Access Compliance Report

Public Rights-of-Way

(Curb Ramps)

Intersection ID: 42959	Main Street: APPLE_DOVE_CT	Cross Street: QUAIL_ST	Location: NW
ADA ID: AEBCCF306615	Ramp Type: PerpDiag	Initial Pass/Fail: Fail	Overall Compliance: No
Severity Score: 21.25			
Codes/Mitigation Info/Possible Solution		Field Measurements/Component Compliance

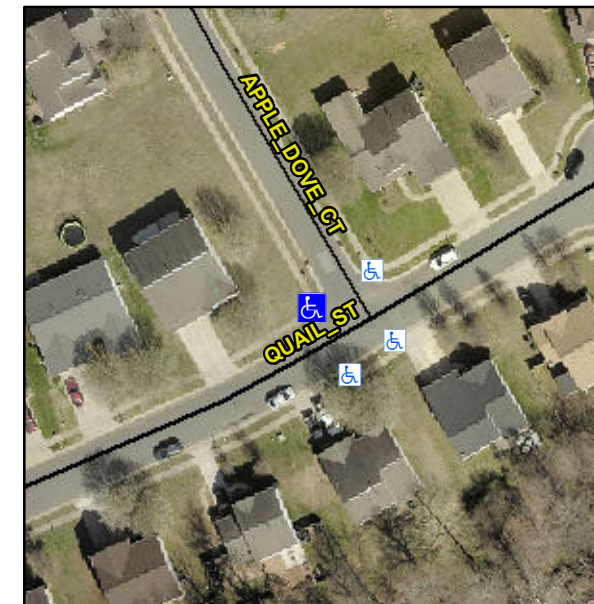
R304.5.1, R304.2.2

Compliance	Description	Data	Compliance	Description	Data
N/A	Ramp Length (in)	48.0	No	Ramp Slope (%)	11.8
No	Ramp Width (in)	46.5	Yes	Ramp XSlope (%)	0.9
N/A	Flare Type LT	N/A	N/A	Flare Type RT	N/A
N/A	Flare Slope LT (%)	N/A	N/A	Flare Slope RT (%)	N/A
N/A	Flare Traversable LT?	N/A	N/A	Flare Traversable RT?	N/A
N/A	Landing Length (in)	N/A	N/A	DWS Provided?	N/A
N/A	Landing Width (in)	N/A	N/A	DWS Contrast?	N/A
N/A	Landing Slope (%)	N/A	N/A	DWS Length (in)	N/A
N/A	Landing X Slope (%)	N/A	N/A	DWS Full Width?	N/A
N/A	Landing Curb? (Y/N)	N/A	N/A	DWS Offset (in)	N/A
N/A	Shared Landing?	N/A			
N/A	Gutter Ponding?	N/A	N/A	Gutter Slope (%)	N/A
N/A	Gutter Lip Ht (in)	N/A	N/A	Gutter X Slope (%)	N/A
N/A	Painted X Walk1?	No	N/A	Painted X Walk2?	No
	X Walk 1 Direction	To S		X Walk 2 Direction	To E
N/A	X Walk 1 Width (in)	N/A	N/A	X Walk 2 Width (in)	N/A
	X Walk 1 Slope (%)	1.2		X Walk 2 Slope (%)	3.8
	X Walk 1 X Slope (%)	2.6		X Walk 2 X Slope (%)	3.0

Remove & Replace Curb Ramp With Two New Directional Ramps or Equivalent.
